Duke Energy Carolinas, LLC
Oconee Nuclear Station (ONS), Units 1, 2, and 3
Docket Numbers 50-269, 50-270, and 50-287
Renewed Facility Operating License Nos. DPR-38, DPR-47, and DPR-55

Subject: Response to Request for Additional Information Related to Proposed Revisions to the Updated Final Safety Analysis Report Section for the Standby Shutdown Facility; License Amendment Request No. 2017-03, Supplement 1 Revision

**DUKE ENERGY RESPONSE TO NRC REQUEST FOR ADDITIONAL INFORMATION
[NON-PROPRIETARY]**

**Turbine Building Flood Analysis
Region 5 Case eoc.min
Fixed HTC vs. RETRAN Selected HTC
RAI-1.B Figure 1**

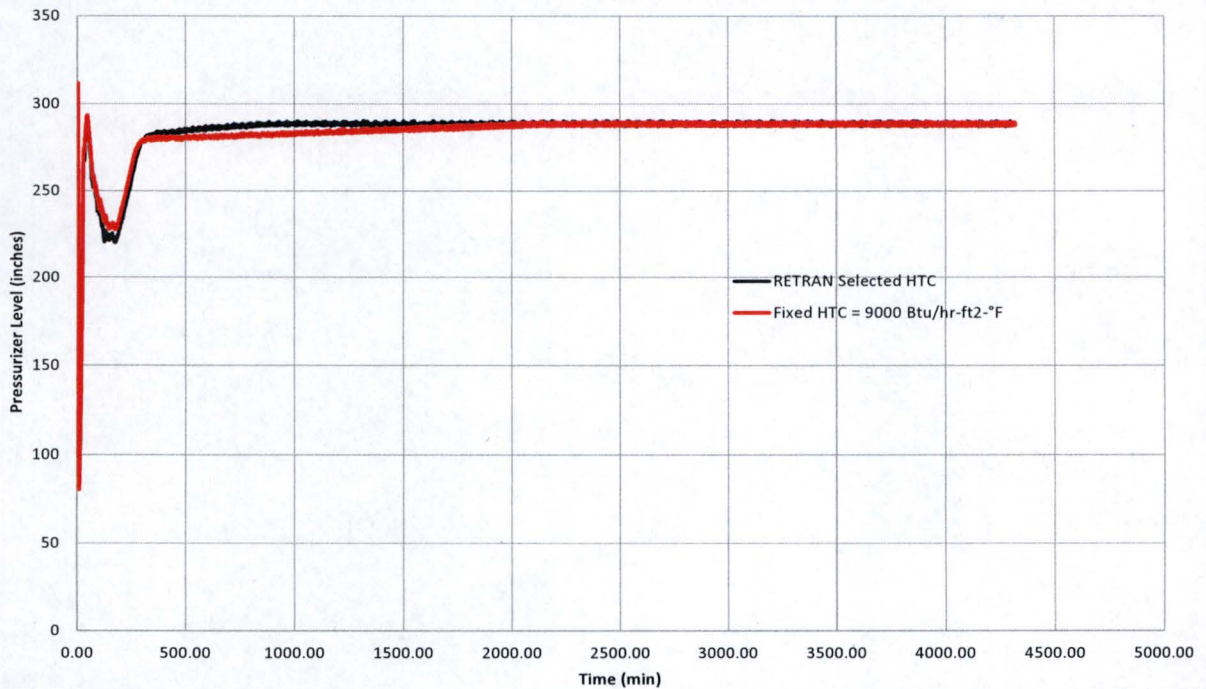
The model modifications needed for the RCS and pressurizer ambient heat losses resulted in the use of an extremely large heat transfer coefficient on the inside pipe wall surfaces, with the actual heat transfer to the environment being controlled on the outside surfaces. The use of a large heat transfer coefficient will result in the inside wall surface temperature and fluid/saturation temperature being very close together and will affect the condensation rate (and resulting RCS pressure), as condensation is based on the temperature difference (ΔT). The staff requests the licensee to explain why this is an acceptable modelling method for both overheating and overcooling events and how the results would be different if the inside wall heat transfer coefficient was calculated by RETRAN.

RAI-1.B Figures 1 through 5 show a comparison of the transient response for the eoc.min cases (overheating event) in which a user defined heat transfer coefficient is used vs. allowing RETRAN to select the HTC's. RAI-1.B Figures 1 and 4 (RCS pressure and RCS subcooling) show that there is a small difference in the transient response during the first ~2000 minutes of the event. The minimum RCS pressure response (Figure 1) during this time is lower for the case in which RETRAN selects the HTC's by ~130 psi, which is reflected in a lower minimum subcooling margin (Figure 4) of ~26°F (~10°F lower). After this time, the pressurizer re-saturates at a more rapid rate when RETRAN determines the HTC's, resulting in a more rapid repressurization of the RCS by 2000 minutes. After this time, there is a negligible difference for the remainder of the transient.

The results of these cases show that the success criteria associated with this event would not be challenged when using either a fixed HTC or allowing RETRAN to determine the HTC.

**Turbine Building Flood Analysis
Region 5 Case eoc.min
Fixed HTC vs. RETRAN Selected HTC
RAI-1.B Figure 2**

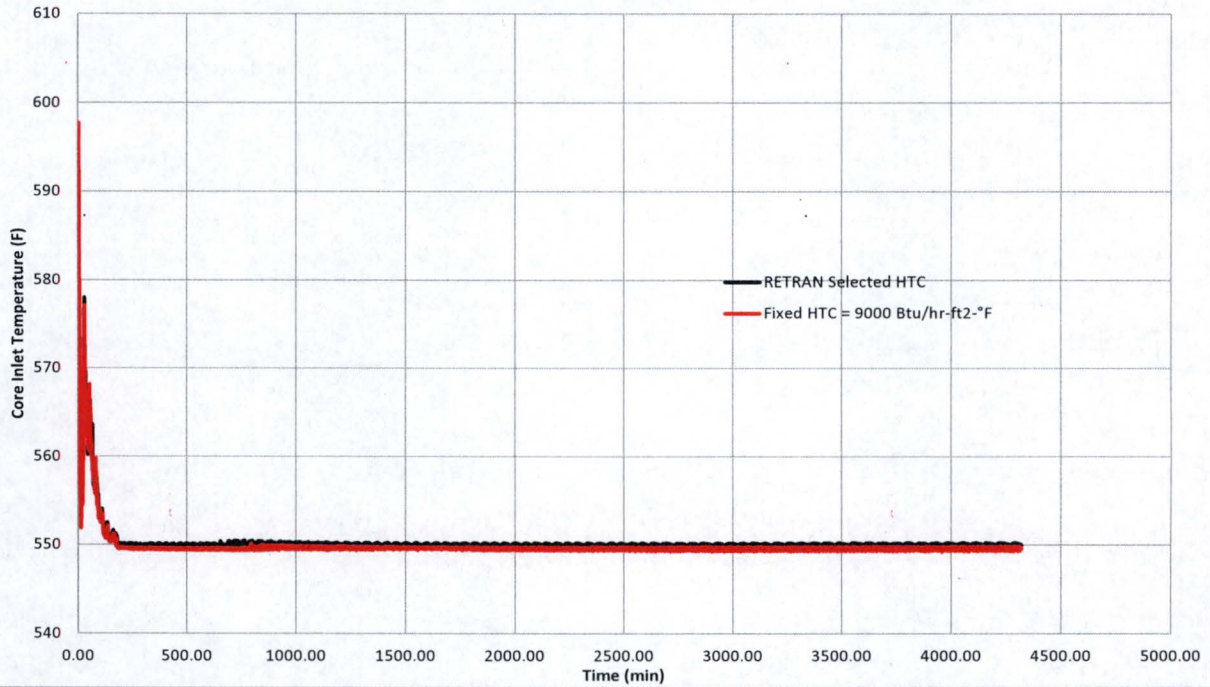
RAI-1.B Figures 2, 3, and 5 show the pressurizer level, core inlet temperature, and SG pressure response for the comparison cases. These figures show there is a negligible difference in these parameters for the duration of the event.

**Turbine Building Flood Analysis
Region 5 Case 85.min
Fixed HTC vs. RETRAN Selected HTC
RAI-1.B Figure 7**

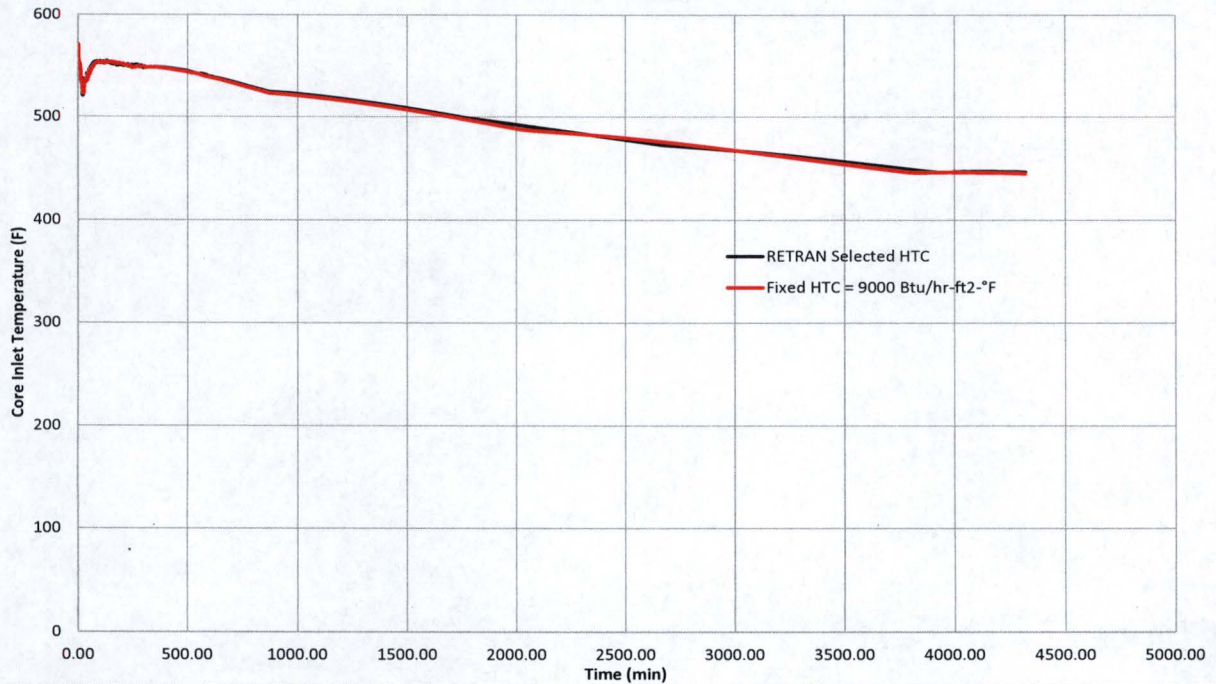
RAI-1.B Figures 7, 8, and 10 show the pressurizer level, core inlet temperature, and SG pressure response for the comparison cases. These figures show there is a negligible difference in these parameters for the duration of the event.
